Re: Review of Draft Final Record of Decision (ROD) for O.U. 3-13,
Idaho Chemical Processing Plant.

COMMENTS ON DRAFT FINAL O.U. 3-13 ROD				
#	Pg.	Sect.	Concern	Suggested Change
1. **	iv	Assessment ...	Language does not tract statutory language	Substitute "imminent and substantial endangerment" for "unacceptable risk or threat"

Figure 11-5. SRPA contingent remediation flowchart

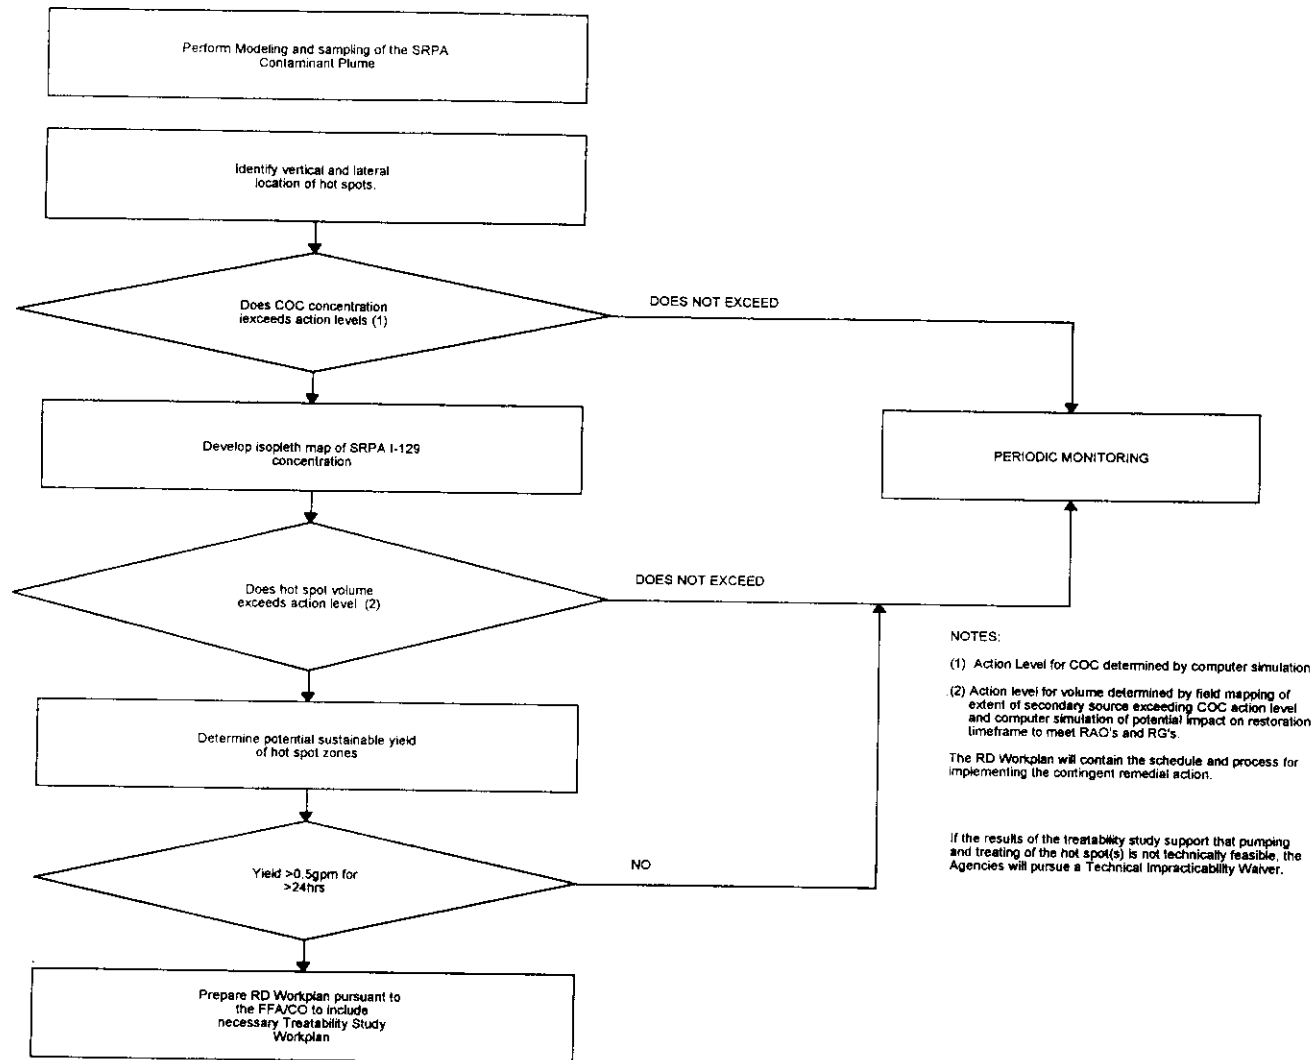
New Figure 11-5 **
